Access Compliance Report Public Rights-of-Way (Curb Ramps)

Main Street: CECIL_PASTURE_RD Cross Street: CECIL_PASTURE_RD Location: E

ADA ID: RPRK211102124457 Ramp Type: Type 4 - Parallel Initial Pass/Fail: Fail Overall Compliance: No Severity Score: 2

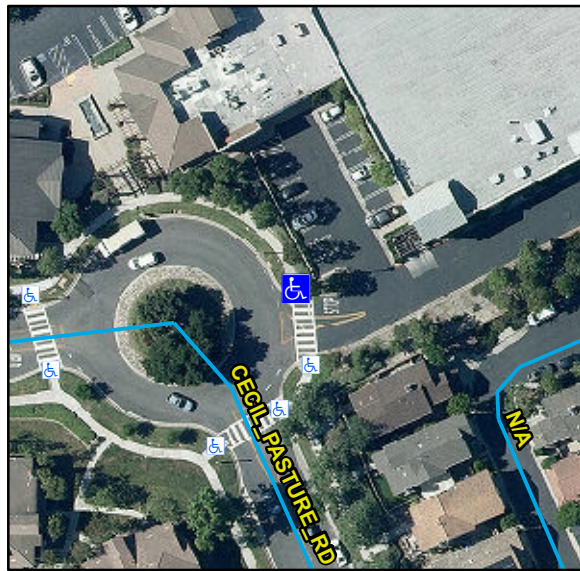
R304.2.2, R304.5.3, STD 1115

Compliance	Description	Data	Compliance	Description	Data
N/A	Ramp Length LT (in)	83	N/A	Ramp Length RT (in)	-9999
Yes	Ramp Width LT (in)	66	N/A	Ramp Width RT (in)	-9999
Yes	Ramp Run Slope LT (%)	4.3	N/A	Ramp Run Slope RT (%)	-9999
No	Ramp Cross Slope LT (%)	2.3	N/A	Ramp Cross Slope RT (%)	-9999
N/A	Landing Present	N/A	N/A	DWS Provided	N/A
N/A	Landing Length (in)	N/A	N/A	DWS Contrast	N/A
N/A	Landing Width (in)	N/A	N/A	DWS Length (in)	N/A
N/A	Landing Run Slope (%)	N/A	N/A	DWS Full Width	N/A
N/A	Landing Cross Slope (%)	N/A		DWS Offset Type	N/A
N/A	Landing Movement Obstructed?	N/A	N/A	DWS Offset Left (in)	N/A
	Landing Movement Type	N/A	N/A	DWS Offset Right (in)	N/A
N/A	Landing Shared	N/A			
N/A	Clear Space	N/A			
N/A	Clear Space To Crosswalk (in)	N/A			
N/A	Marked Crosswalk 1	Yes	N/A	Marked Crosswalk 2	N/A
	Crossing 1 Direction	S		Crossing 2 Direction	N/A
	Marked Crosswalk 1 Width (in)	144		Marked Crosswalk 2 Width (in)	N/A

N/A	Ramp Inside Crosswalk 1	Yes	N/A	Ramp Inside Crosswalk 2	N/A
	Crossing 1 Slope (%)	3.5		Crossing 2 Slope (%)	N/A
	Crossing 1 Cross Slope (%)	0.9		Crossing 2 Cross Slope (%)	N/A
N/A	Gutter Ponding	N/A	No	Curb Slope	15.6
Yes	Gutter Lip Height (in)	0		Road Run Slope (%)	N/A
N/A	Gutter Run Slope (%)	N/A		Road Cross Slope (%)	N/A
N/A	Gutter Cross Slope (%)	N/A	Yes	Perpendicular Joint Present	Yes
Yes	Overall Surface Condition	Acceptable			
	Cross Gutter Present?	No		Spandrel Present?	No
	Replace Cross Gutter?	N/A		Replace Spandrel?	N/A

Remove & Replace Entire Ramp.
